TOWN OF RANDOLPH, VERMONT

The Town of Randolph writes this letter to verify that the site plan submitted to the Commission ("Exhibit RDS MS-2A Site Plan") shows that the condition of the Town's December 2021 letter ("Exhibit RDS MS-14") has been satisfied.

Randolph Davis Solar, LLC

PRELIMINARY
SITE PLAN

C-100

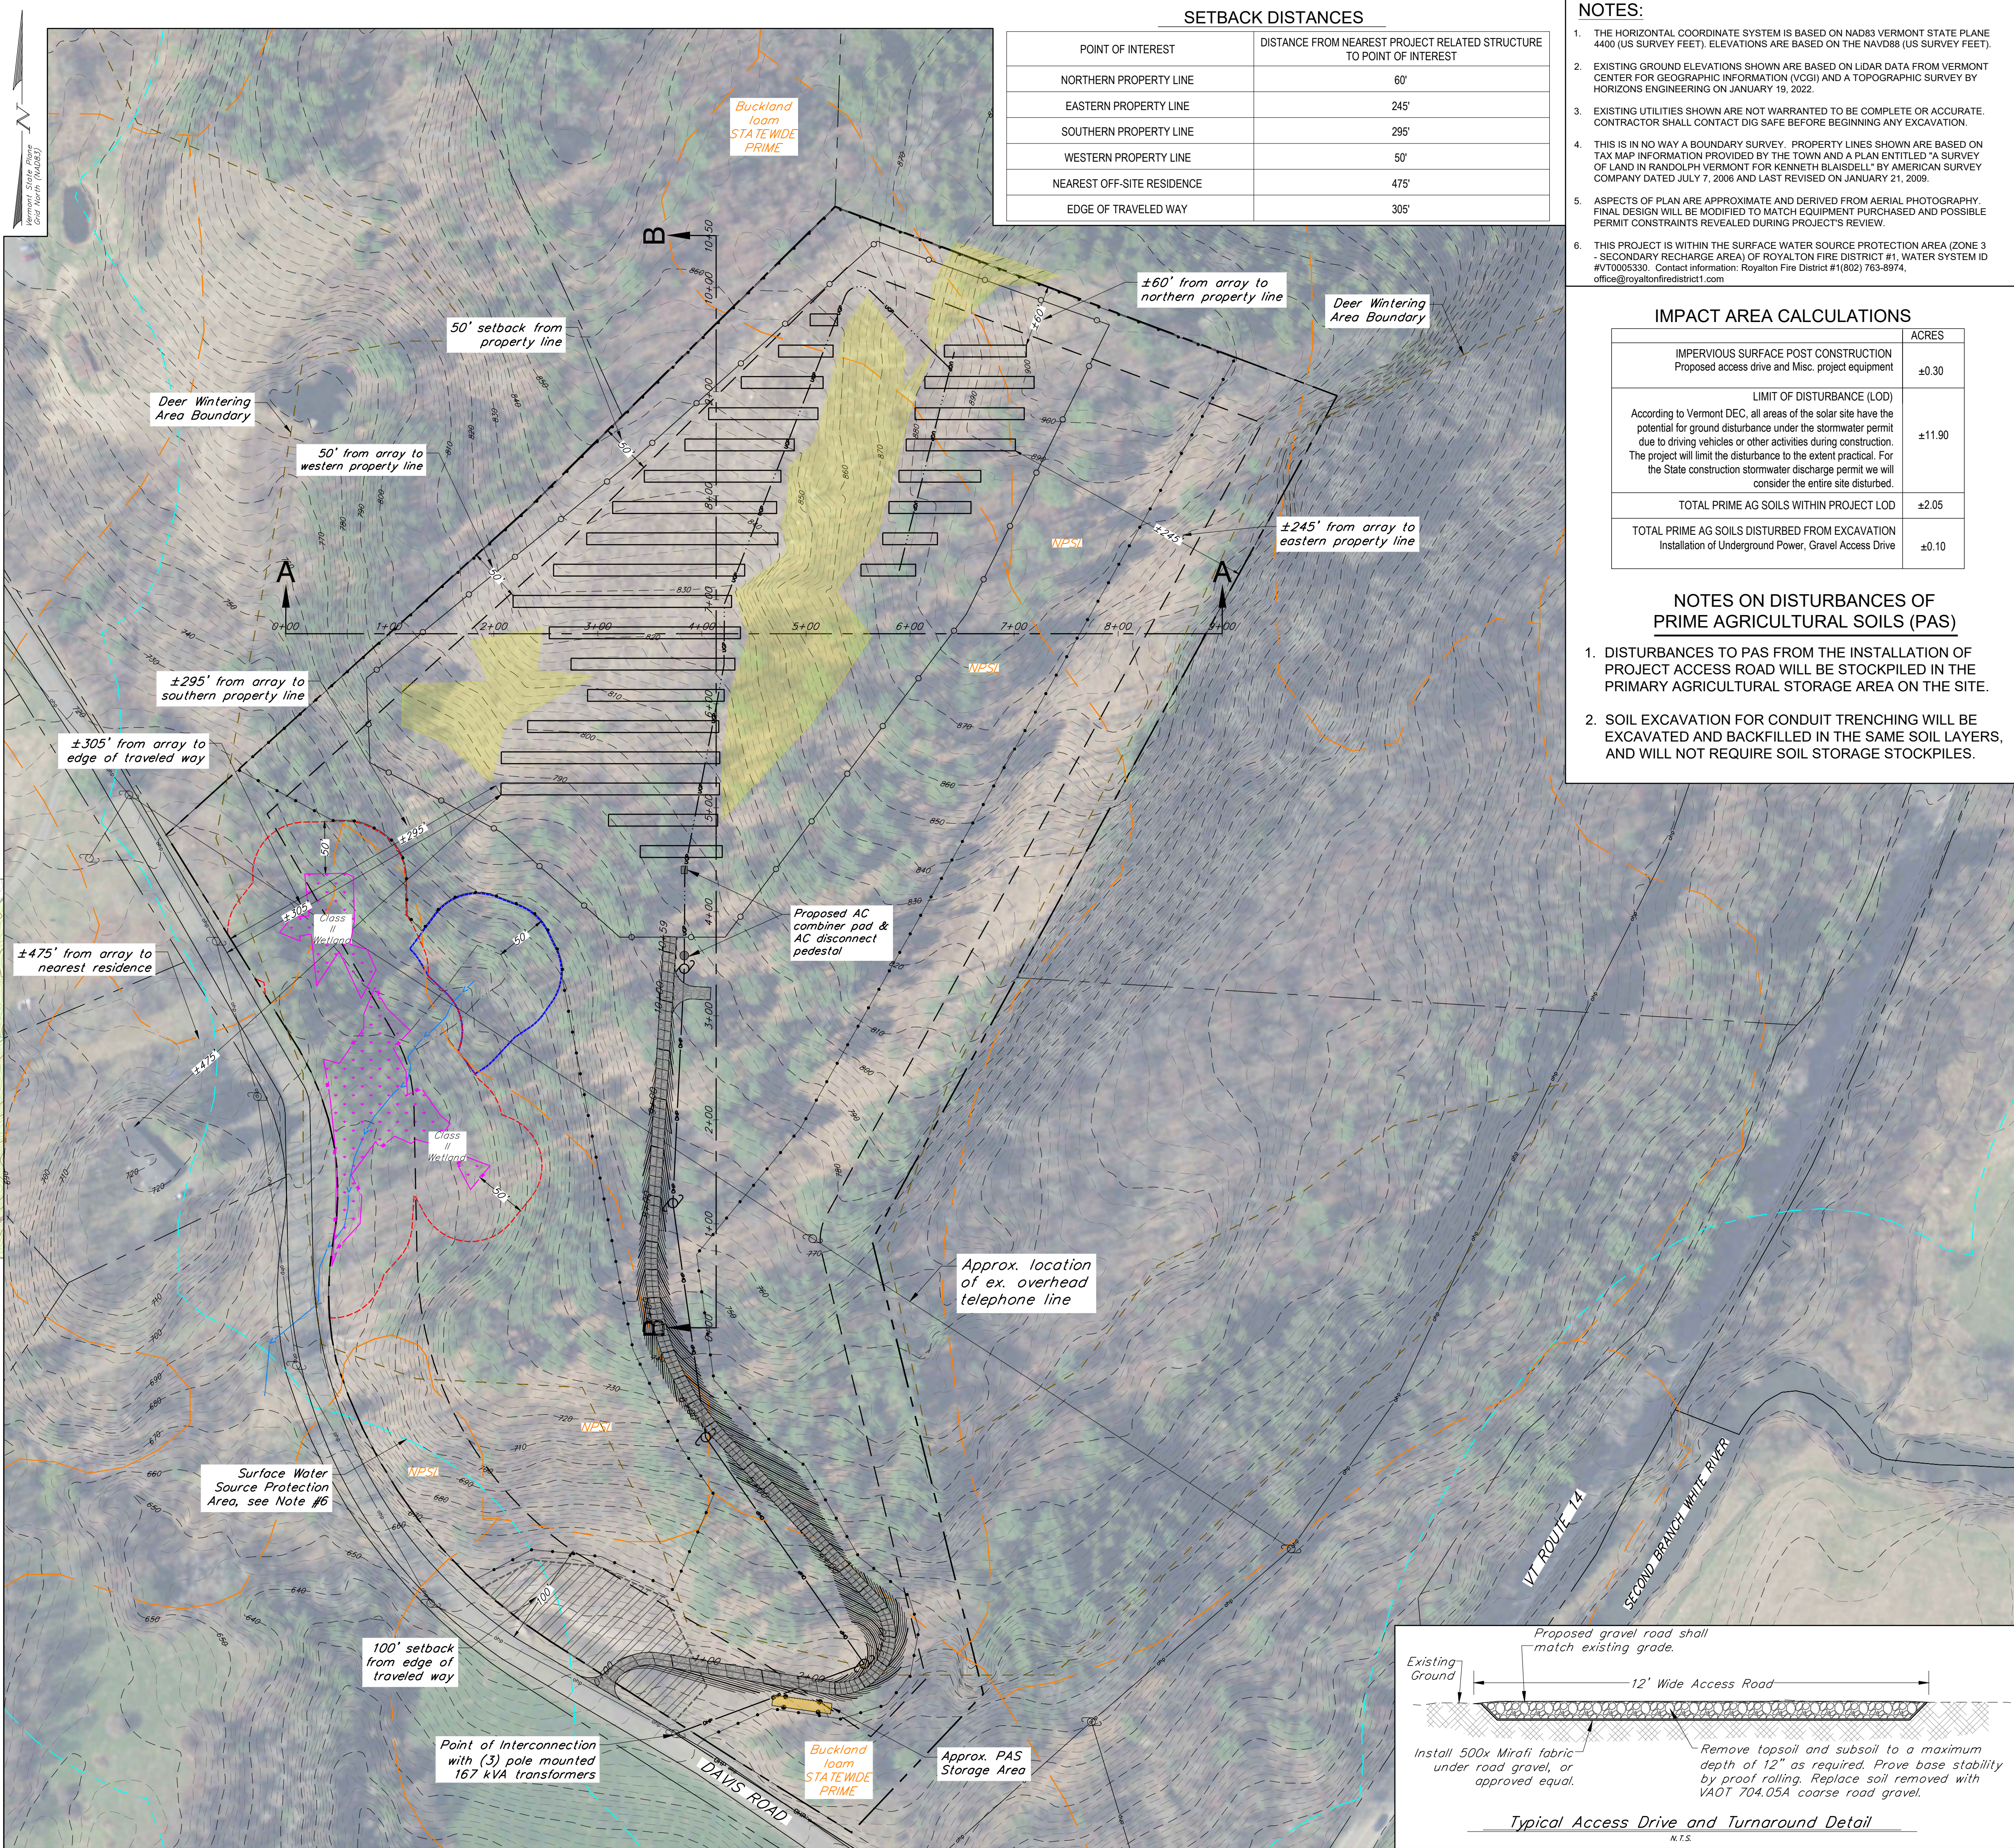
REV	REVISIONS/COMMENTS	DATE
1	Revised array onto existing slopes less than 25%	2-22-22
